March 28, 2014
Subject: **Augusta Phase 2**
State Project No: 020118.20
Amendment No. 2

Make the following change to the Bid Documents:

REVISED (E)MUA DUCT - A1 - SHEET MH102

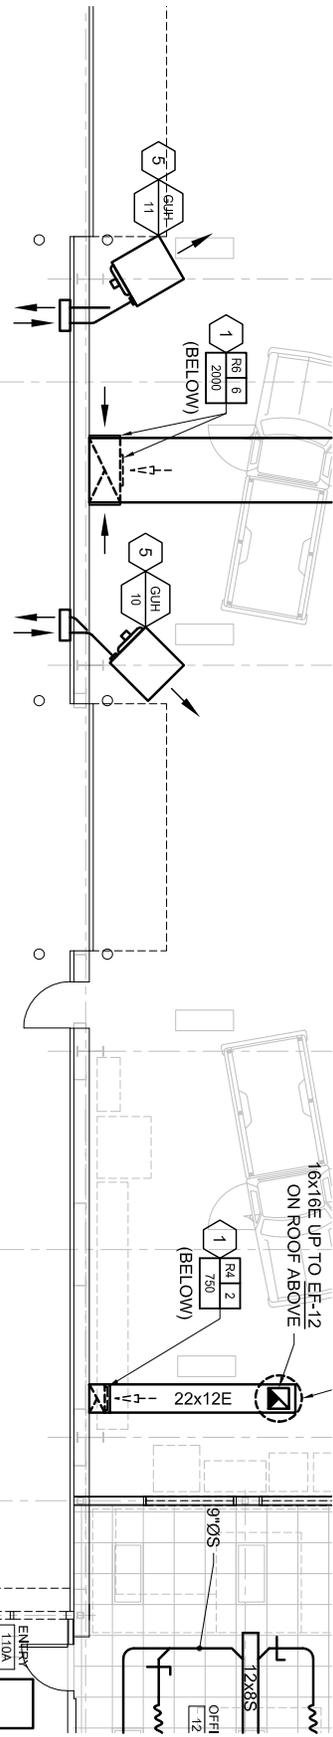
On plan Sheet MH 102 titled Mechanical Roof Plan, **REVISE** drawing per SKM-05 (A1 - Mechanical Roof Plan, Revised (E) MUA ductwork).

REVISED KEYED NOTES
~ A1 - SHEET MH100C

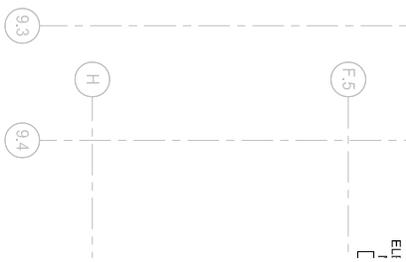
On plan Sheet MH 100C titled Mechanical Part Plan First Floor - Area C, **REVISE** drawing per SKM-04 (A1 - Part Plan, Revised Keyed Notes).

REVISED RELOCATED EQUIPMENT NOTES
 ~ A1 - SHEET MH100C

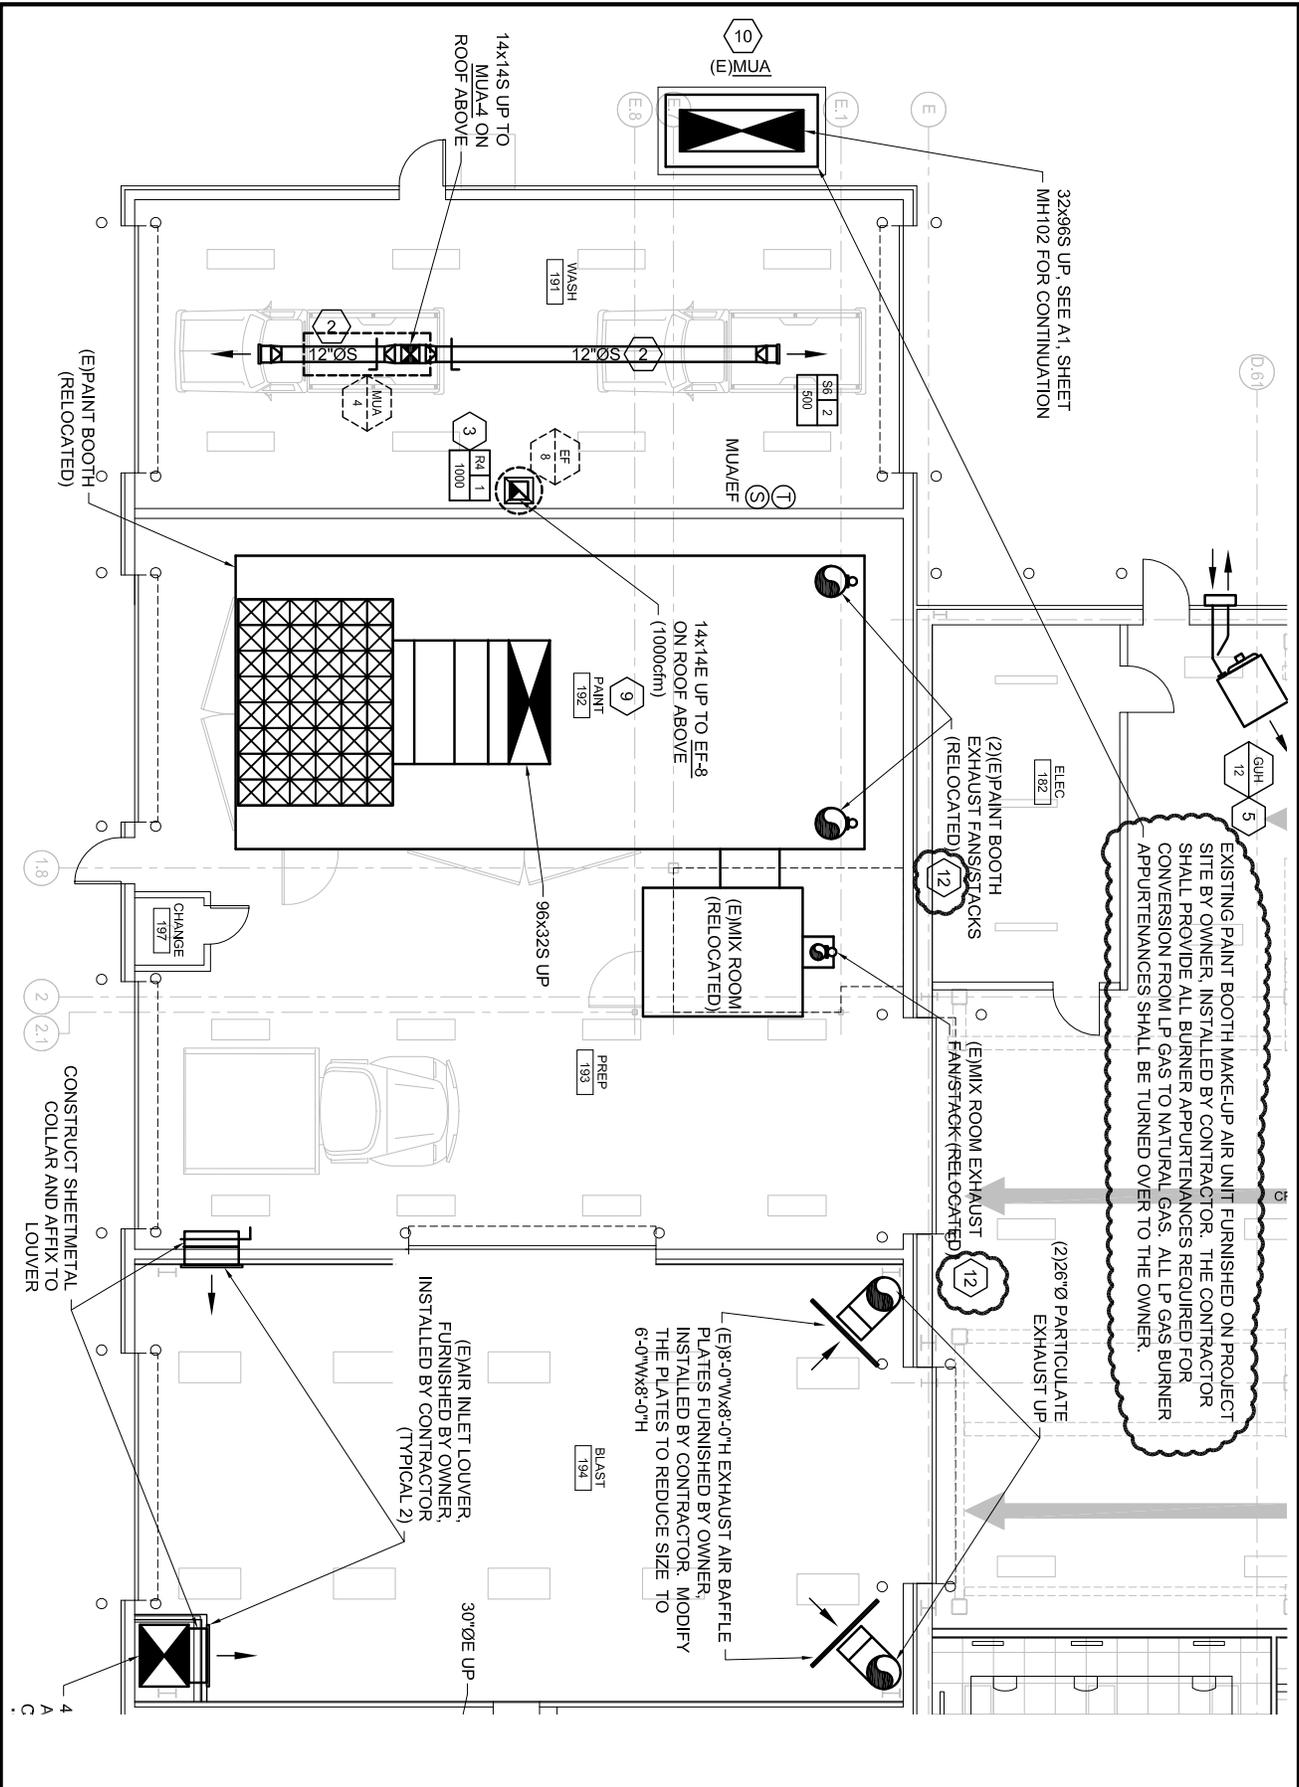
On plan Sheet MH 100C titled Mechanical Part Plan First Floor - Area C, **REVISE** drawing per SKM-03 (A1- Part Plan, Revised Relocated Equipment Note).

COLD STORAGE BUILDING LIGHTING PART PLAN

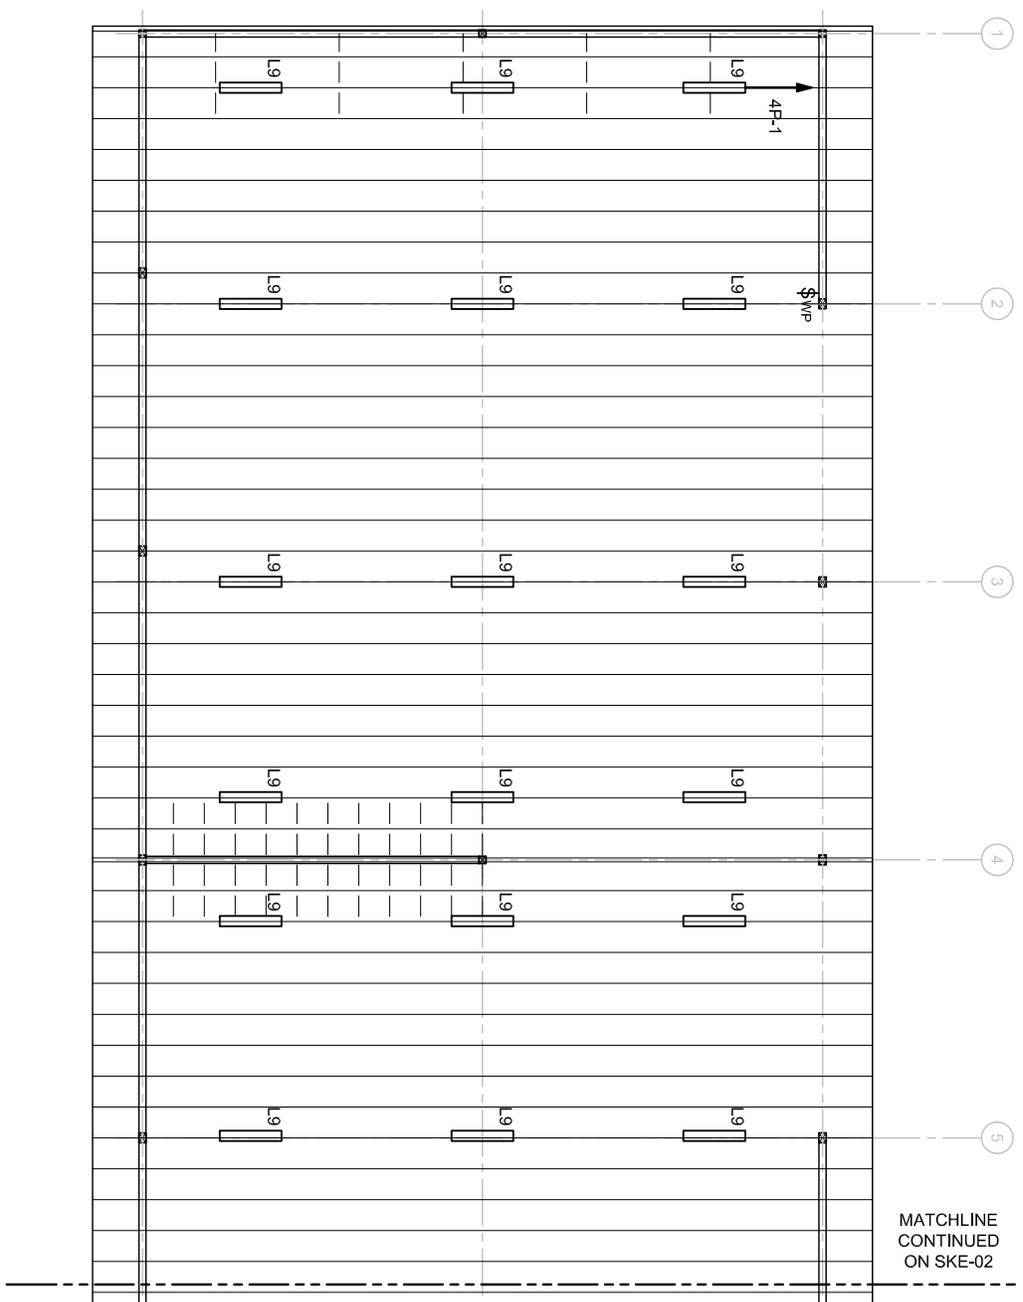
Add plan sheet Titled SKE-01 COLD STORAGE BUILDING LIGHTING PART PLAN.

COLD STORAGE BUILDING LIGHTING PART PLAN

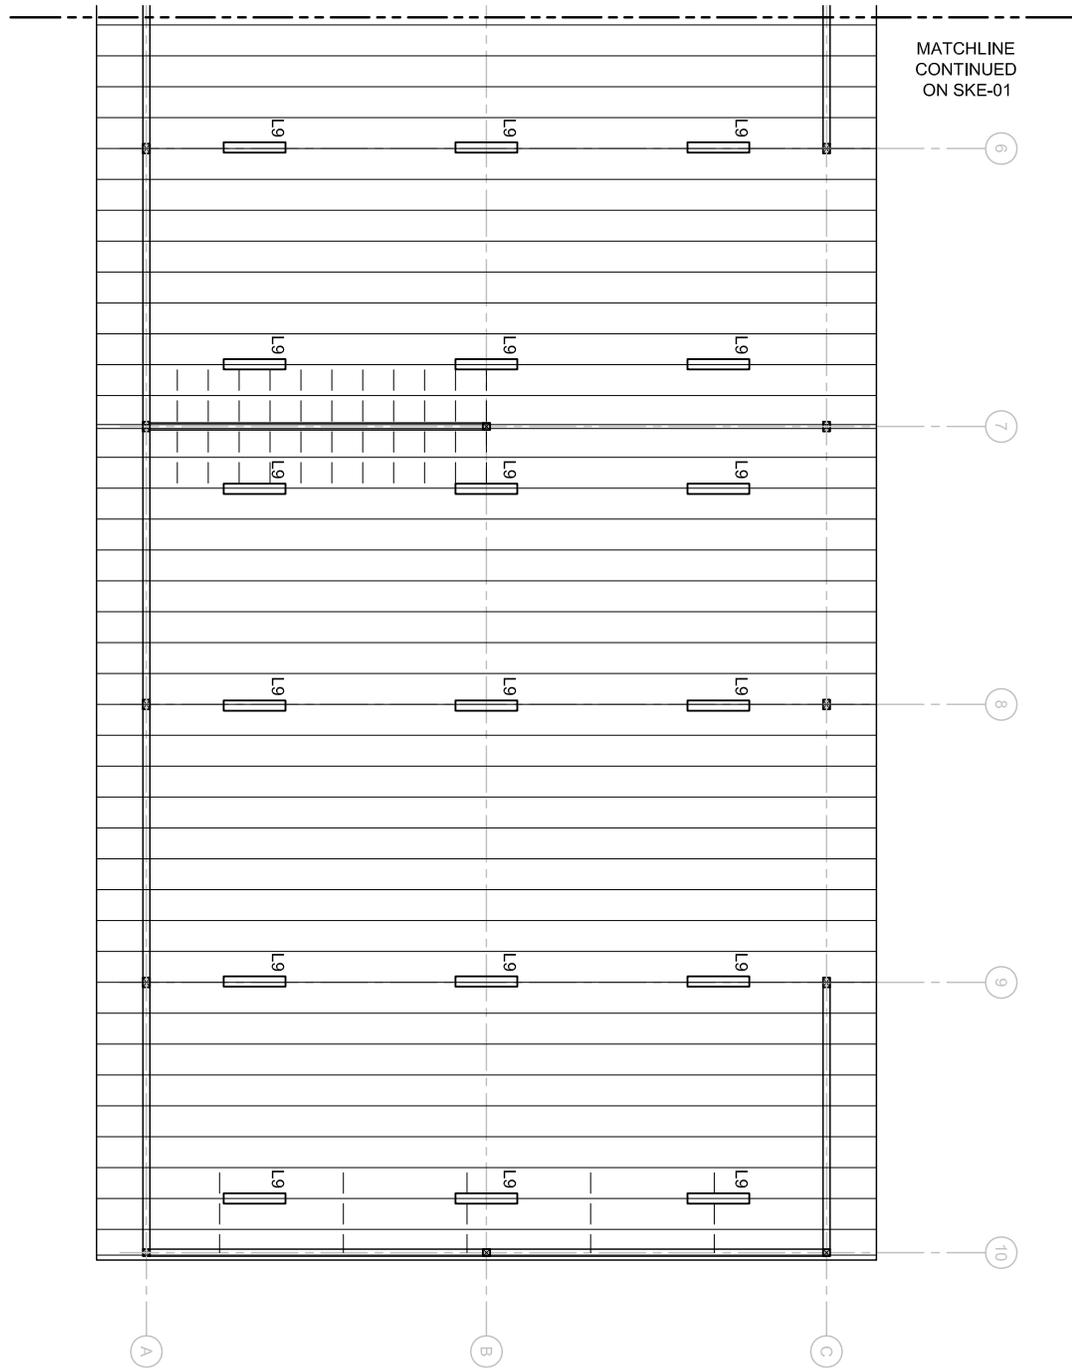
Add plan sheet Titled SKE-02 COLD STORAGE BUILDING POWER AND SYSTEMS PART PLAN.

COLD STORAGE BUILDING POWER AND SYSTEMS
PART PLAN

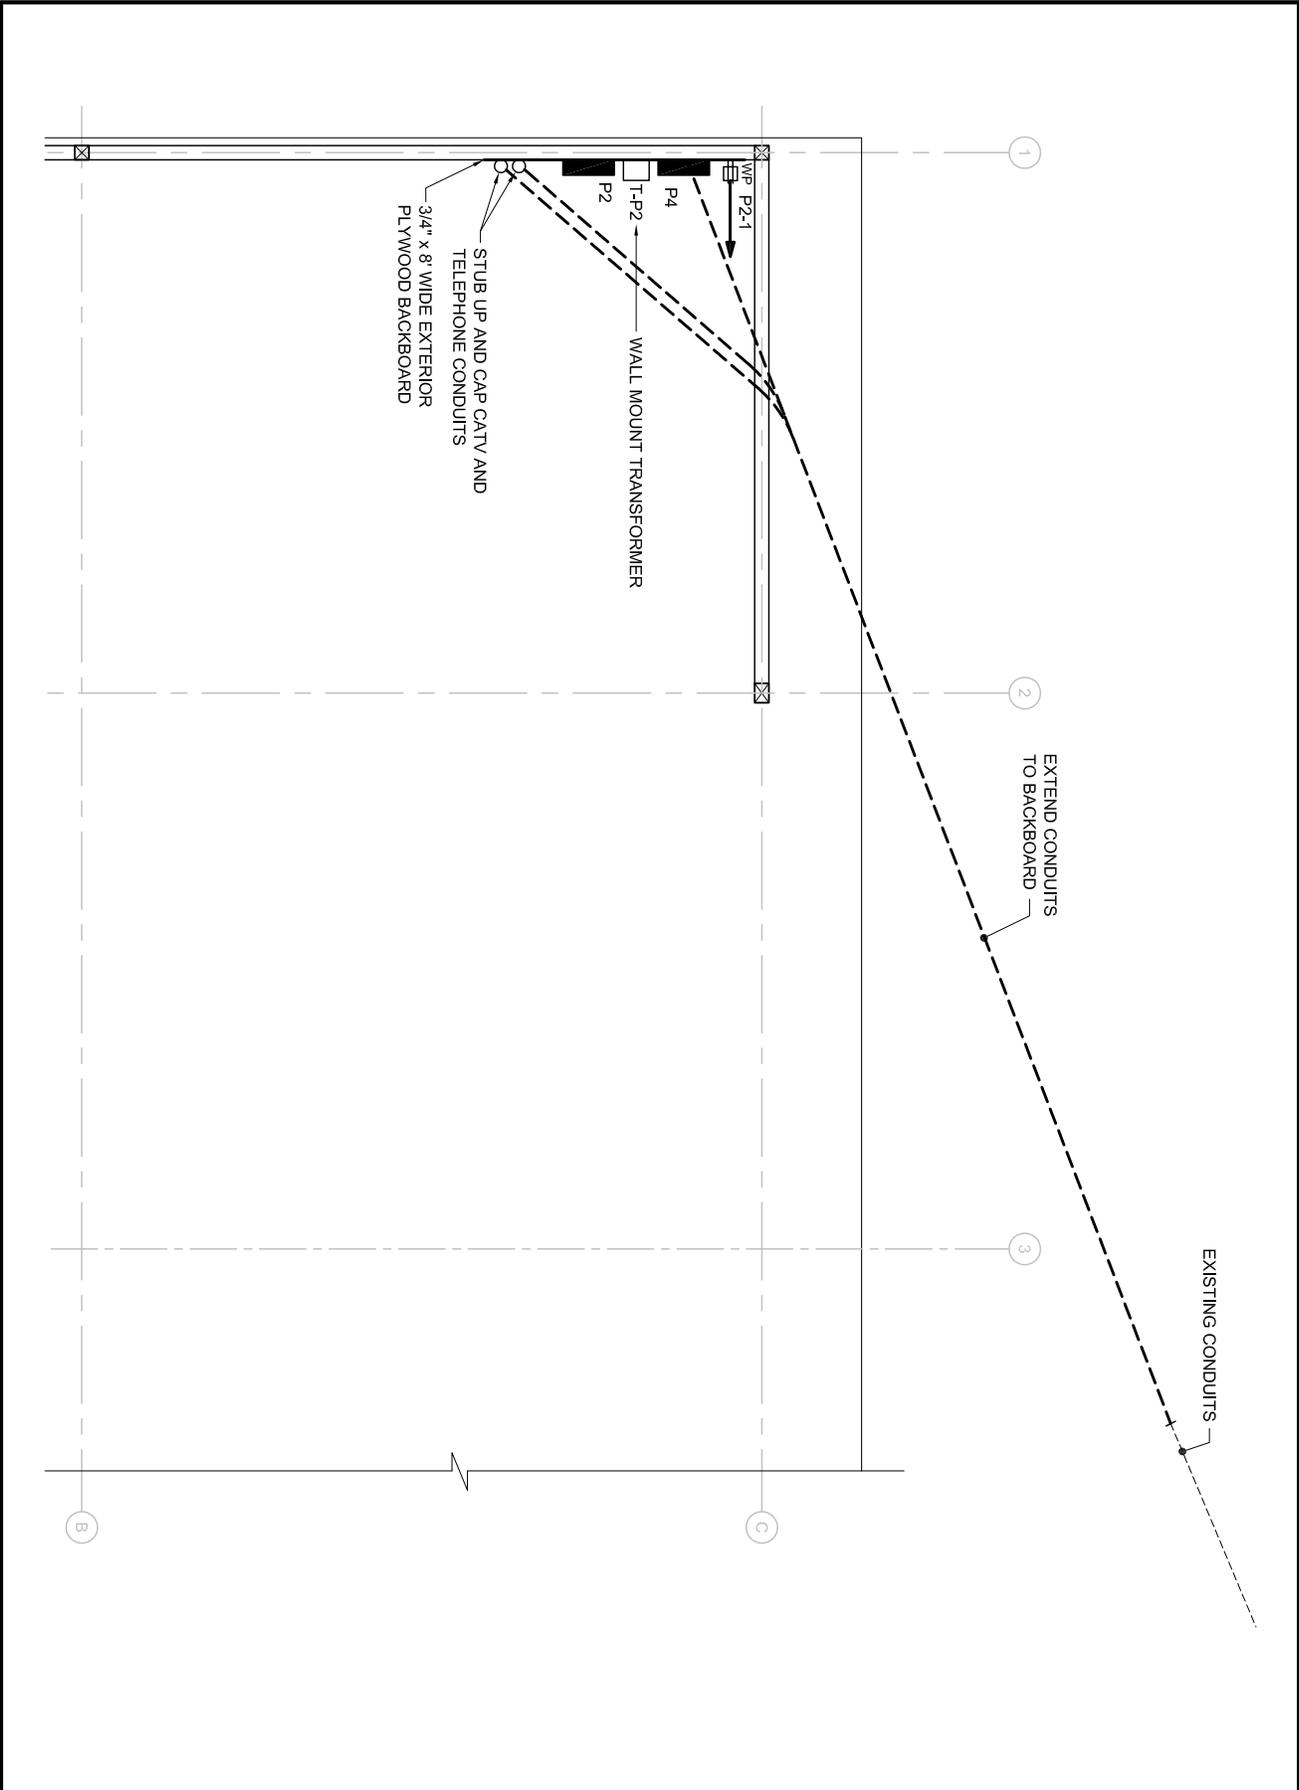
Add plan sheet Titled SKE-03 COLD STORAGE BUILDING POWER AND SYSTEMS PART PLAN.

COLD STORAGE BUILDING POWER RISER DIAGRAM AND LIGHTING CONTROL DETAIL

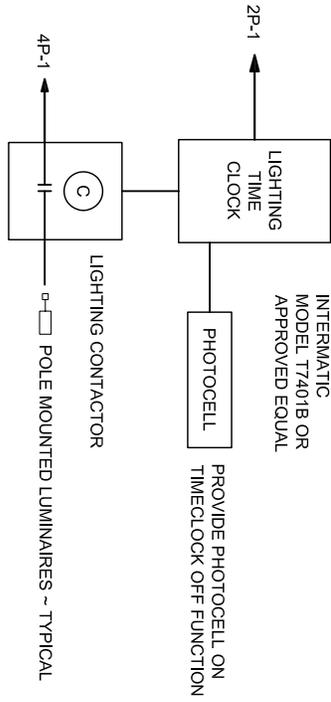
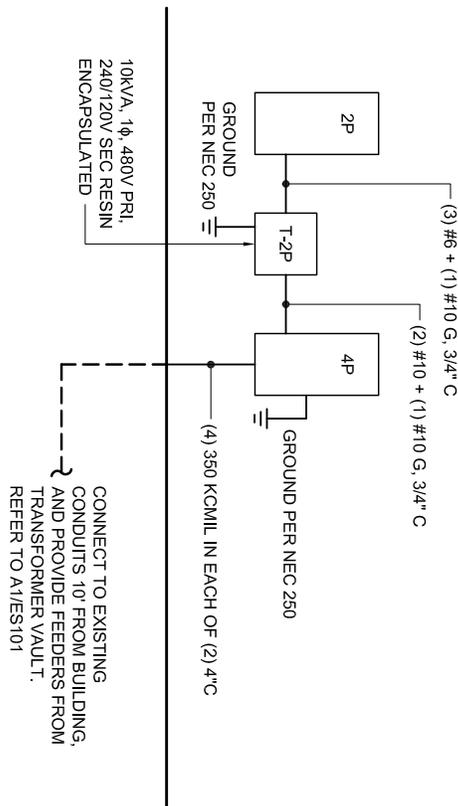
Add plan sheet Titled SKE-04 COLD STORAGE BUILDING POWER RISER DIAGRAM AND LIGHTING CONTROL DETAIL.

REVISED WET/DRY VACUUM SYSTEM PIPING
 ~ A3 - SHEET PL301

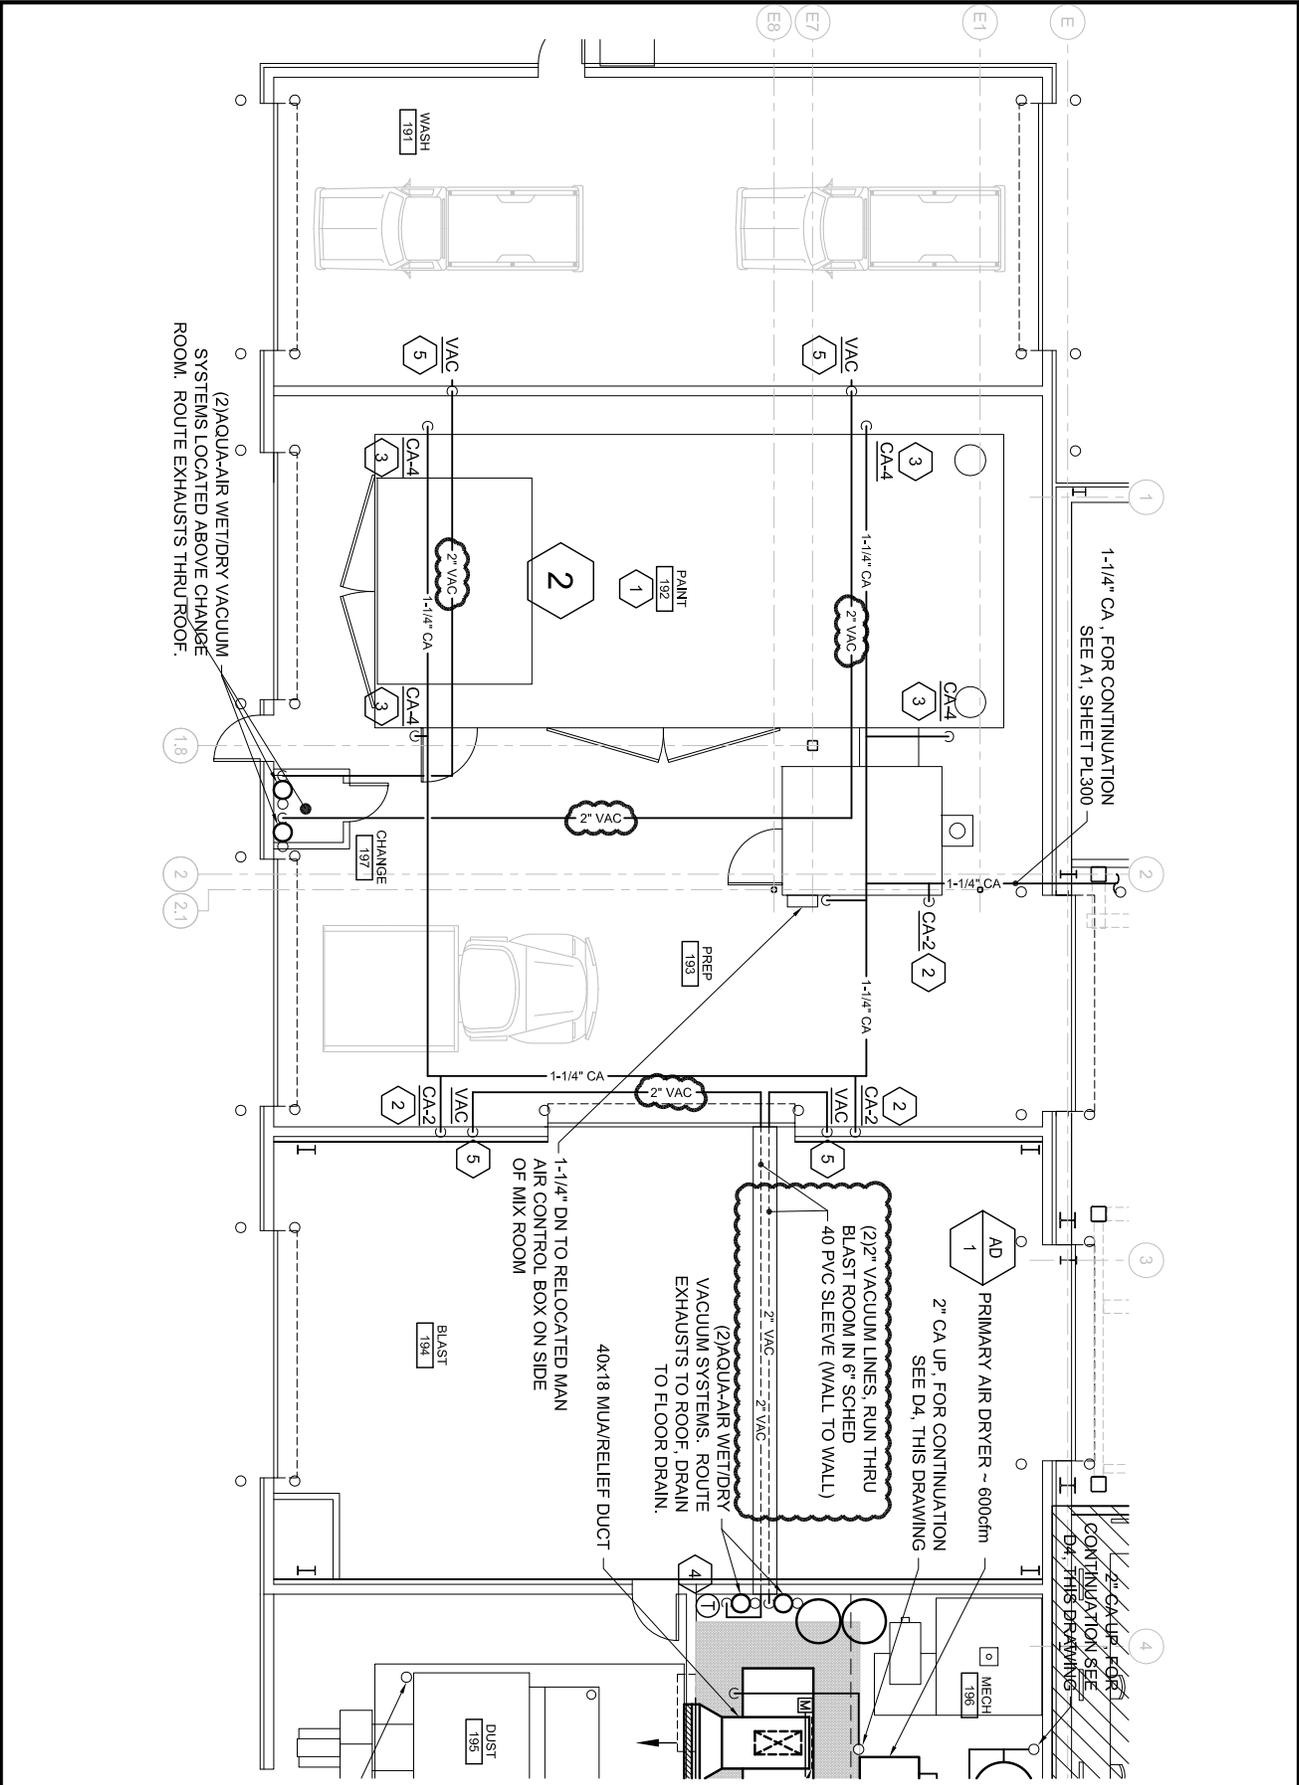
On plan Sheet PL 301 titled Compressed Air/Vacuum Part Plan and Details, **REVISE** Detail A3 as shown on drawing & SKP-04. Make these changes in pen and ink.
